CITY PLAN COMMISSION

FILE NUMBER: S234-038 SENIOR PLANNER: Sharmila Shrestha

LOCATION: Bagley Street, north of Darwin Street

REQUEST: An application to replat a 0.603-acre tract of land containing all of Lots 8, 9, and 10 in City Block 17/8342 to create one lot on property located on Bagley Street, north of Darwin Street.

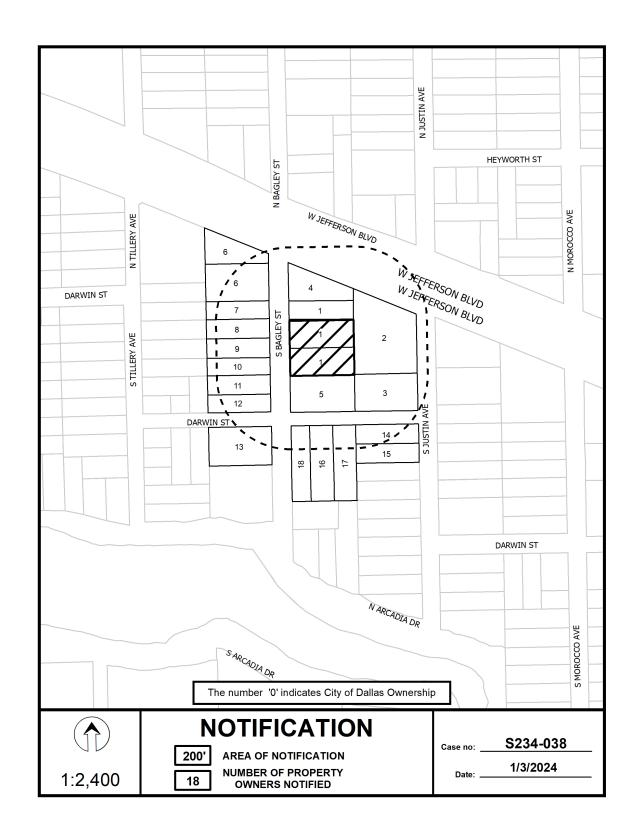
- 19. On the final plat, change "Bagly Street (FKA Katharyn Avenue)" to "Bagley Street (FKA Katharyn Avenue)".
- 20. On the final plat, change "Darwin Street" to "Darwin Street (FKA Laredo Street FKA Live Oak Street)".
- 21. On the final plat, change "Jefferson Boulevard" to "Jefferson Boulevard (AKA Jefferson Avenue)".
- 22. On the final plat, identify the property as Lot 8A in City Block 17/8342.
